# Memorandum

To: Salt Lake City Historic Landmark Commission  
From: Aaron Barlow, Principal Planner, [aaron.barlow@slcgov.com](mailto:aaron.barlow@slcgov.com) or 801-535-6182  
Date: June 1, 2023  
Re: PLNHLC2022-00675 – Trolley North Student Housing Development

This memorandum provides updated information on the proposed Trolley North Student Housing Development New Construction Petition PLNHLC2023-00675. The referenced application was discussed at the Historic Landmark Commission Meeting on January 5, 2023. At that meeting, the commission tabled the request citing shortcomings in the submitted materials and failure to comply with a number of standards. Their feedback was articulated in a letter sent to the applicant (dated January 17, 2023, included in [Attachment I](#)) and was based upon the standards of review for New Construction in a Historic District ([21A.34.020.H](#)) and the Design Guidelines for Historic Apartment and Multifamily Buildings found in [Chapter 12](#): New Construction.

# Comparison of Previous and Revised Submittals

# SHADOW STUDY OF BUILDING STEPBACK

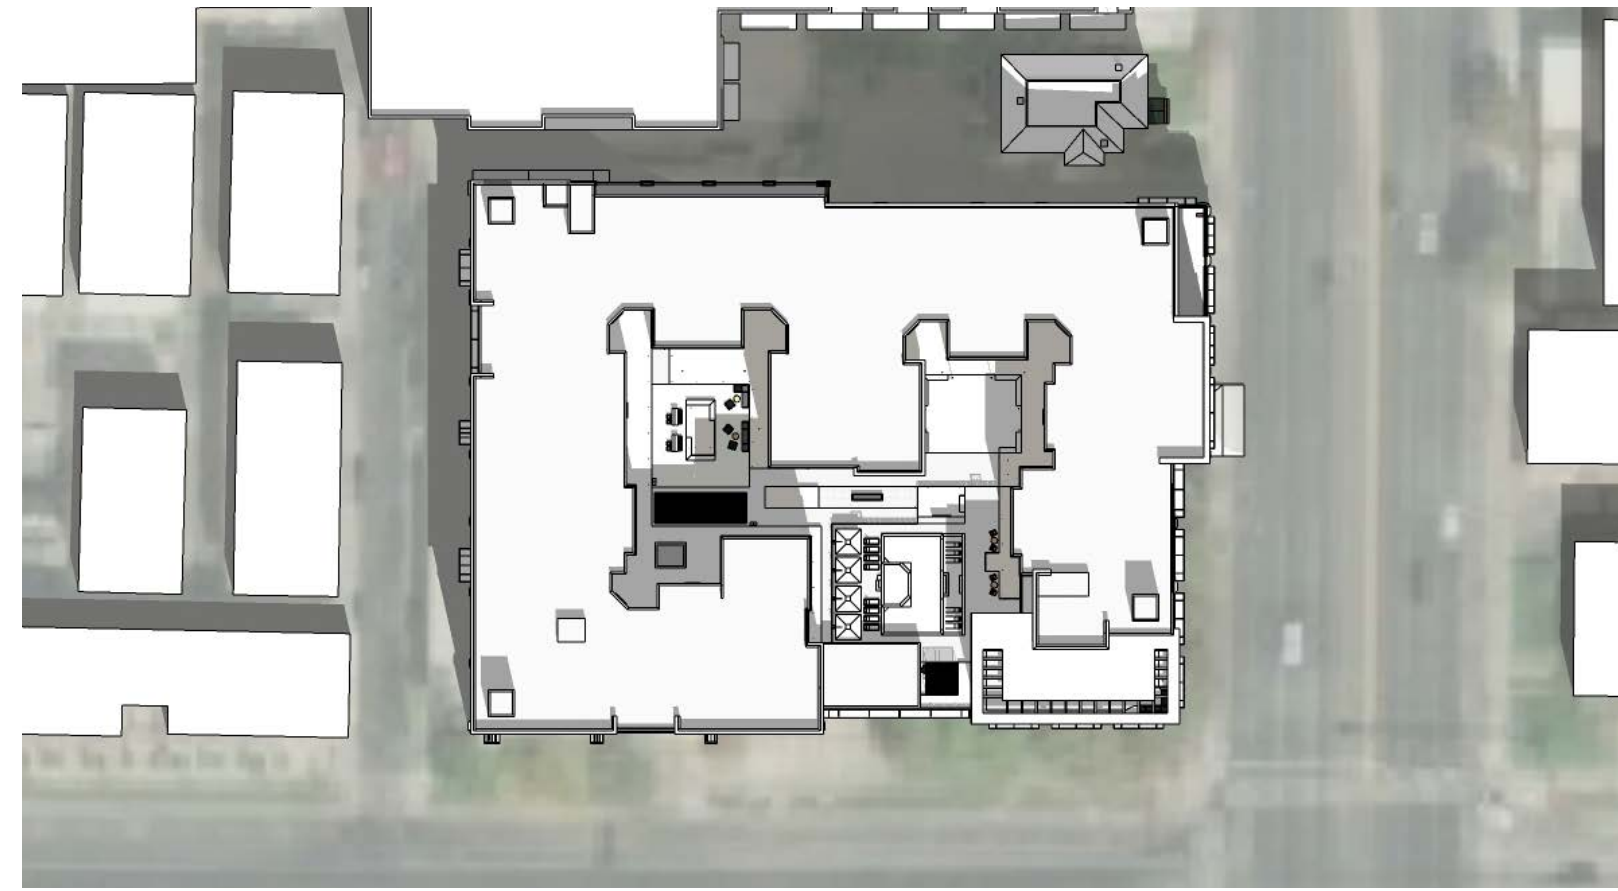
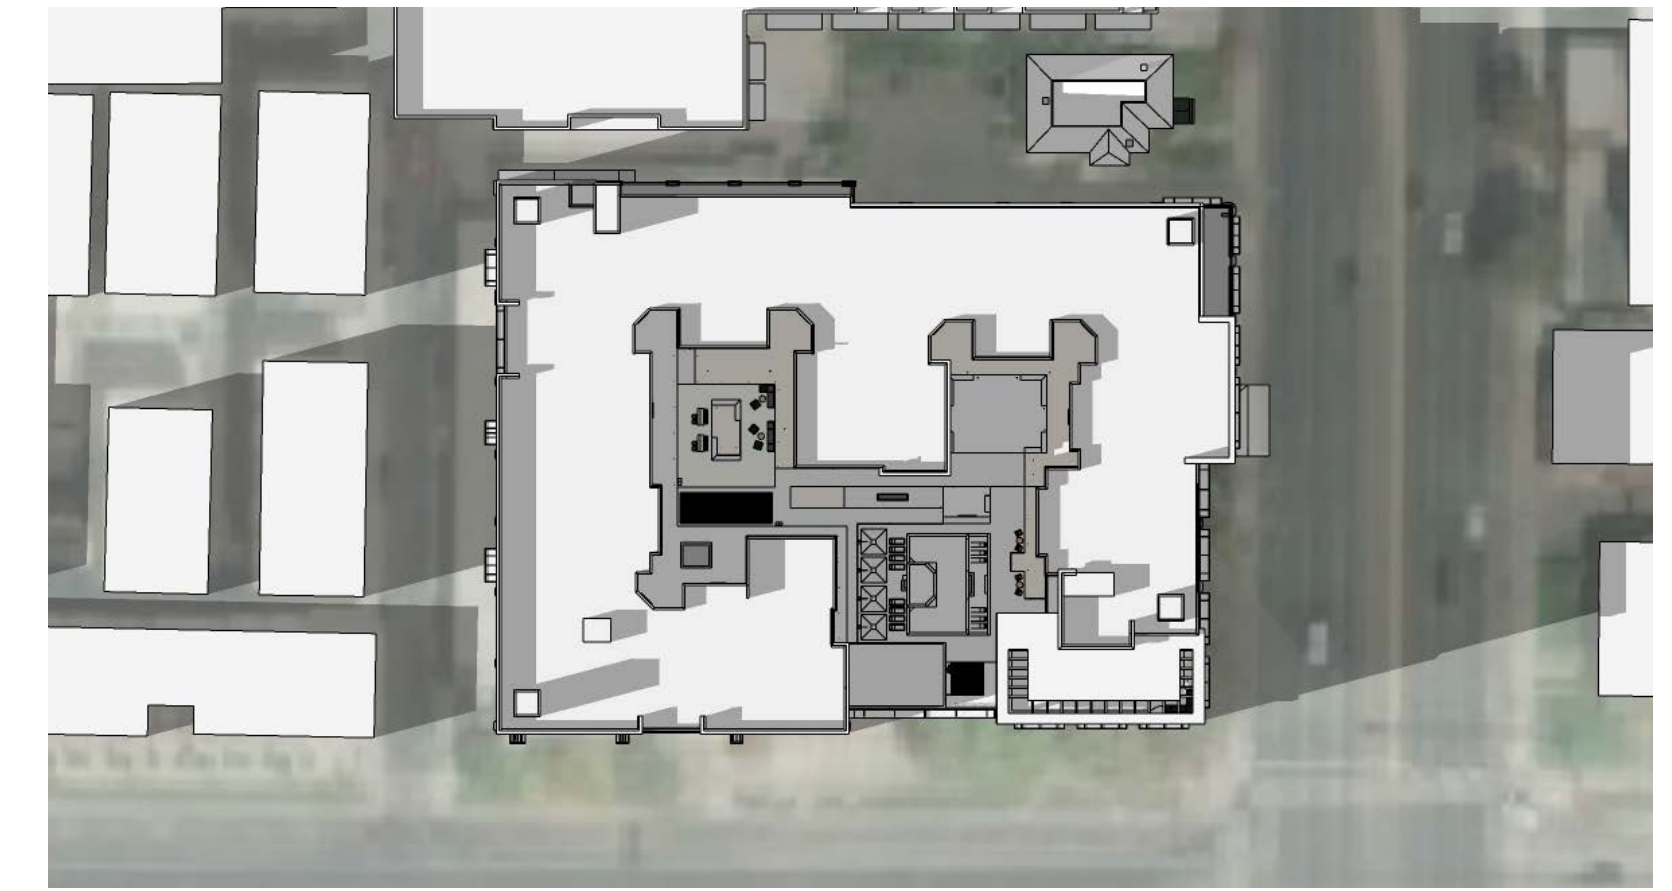
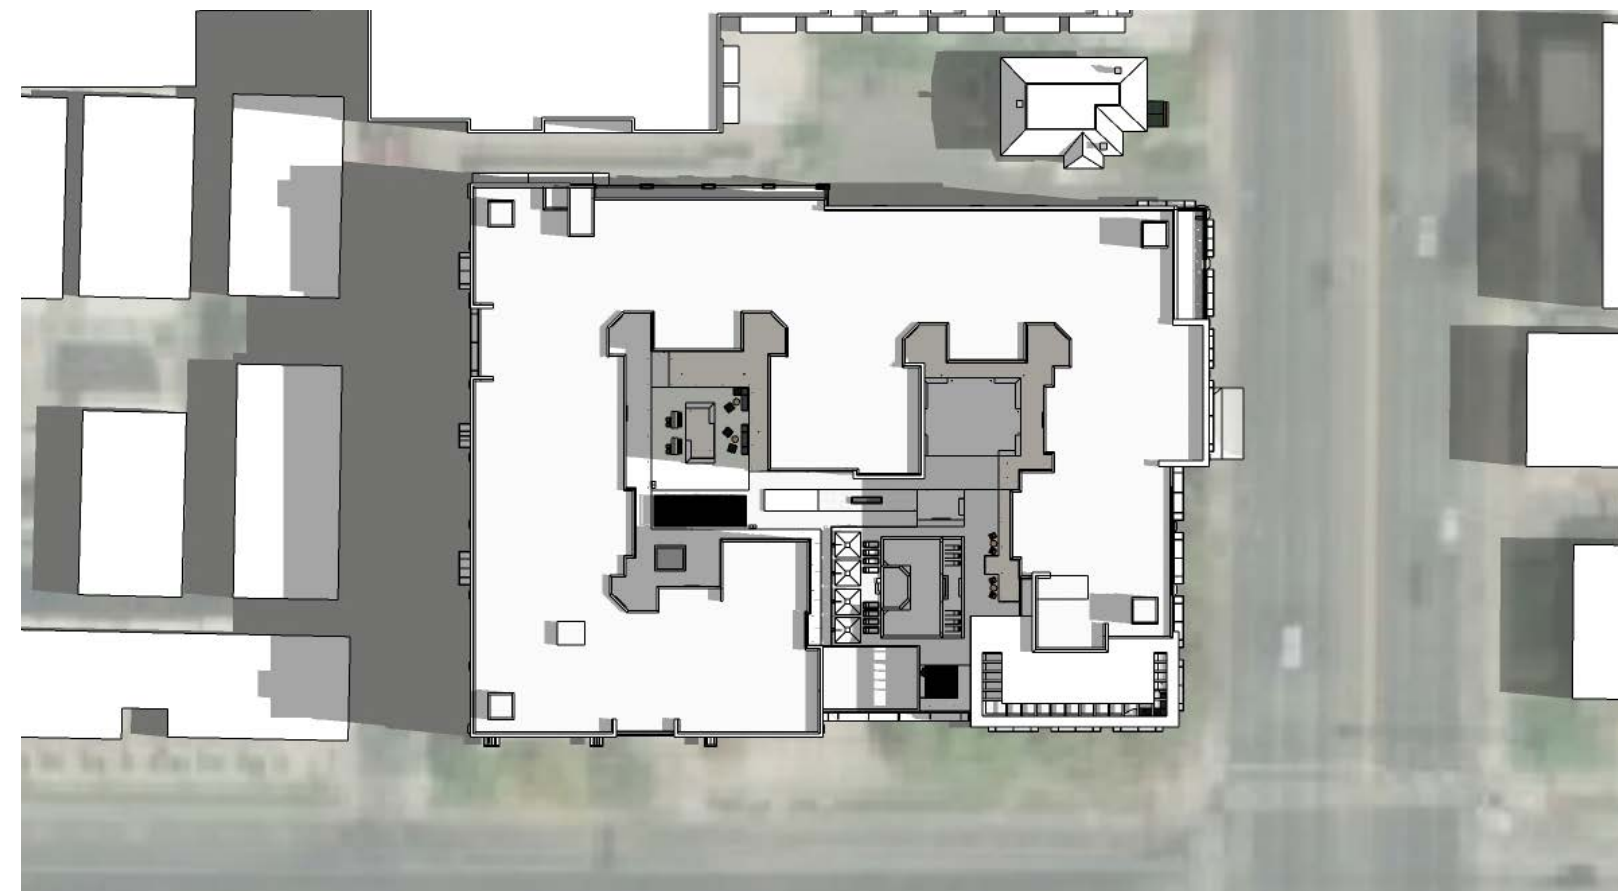
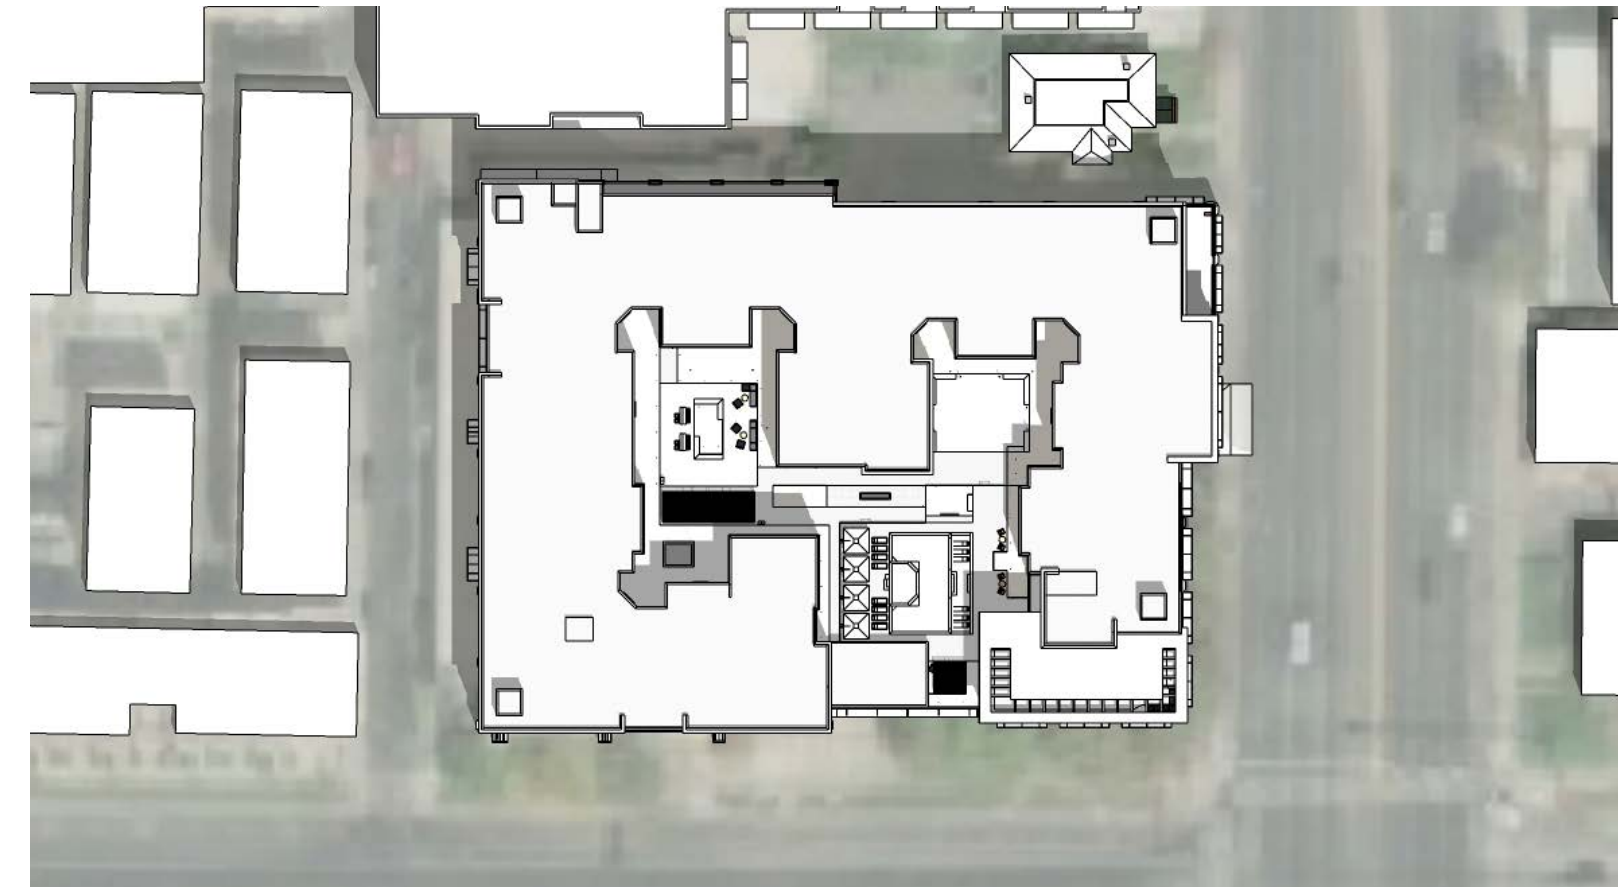
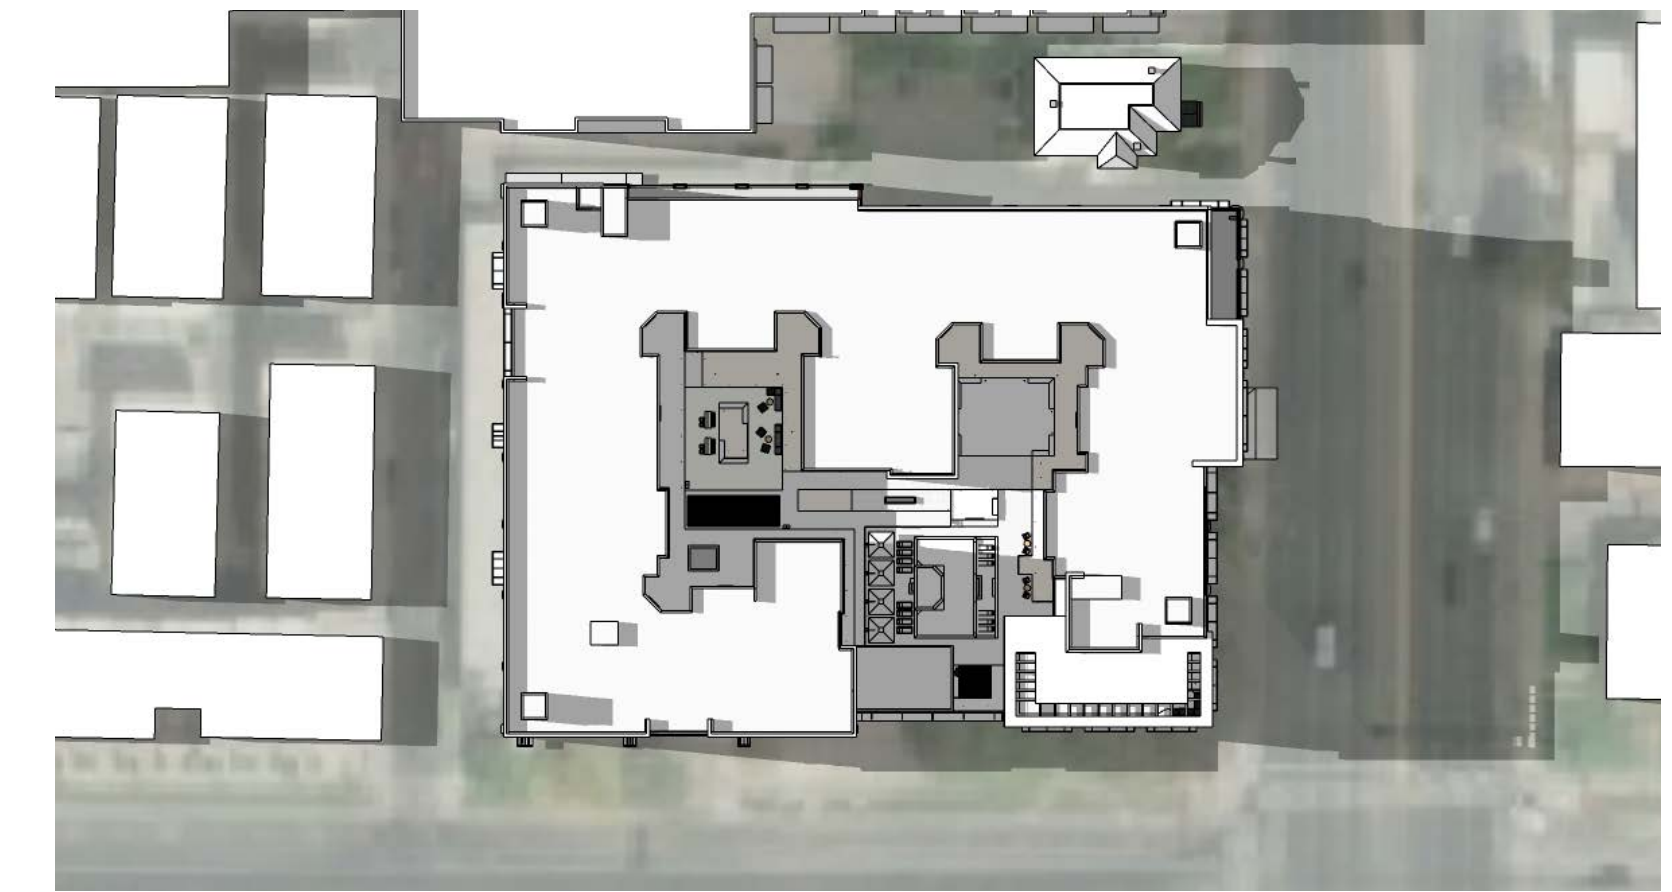
A shade study of the proposed building is required. <ul style="list-style-type: none"> <li>New Construction Standards 1d &amp; 4a</li> <li>Design Guidelines 12.13, 12.12, 12.44</li> </ul>	The updated plans include a shade study that illustrates the expected impact of the proposed building on adjacent property.	<b>Complies</b>
Please confirm that all renderings, elevations, and plans accurately portray the proposed development and buildings within the vicinity.	Staff has reviewed the revised plans for accuracy and has yet to identify any significant issues. While some minor errors may still be present (which, from Planning staff’s perspective, is common for large plan sets like these), they do not detract from the interpretation of the plans and should not prevent the commission from making a well-informed decision on the proposal.	<b>Complies</b>
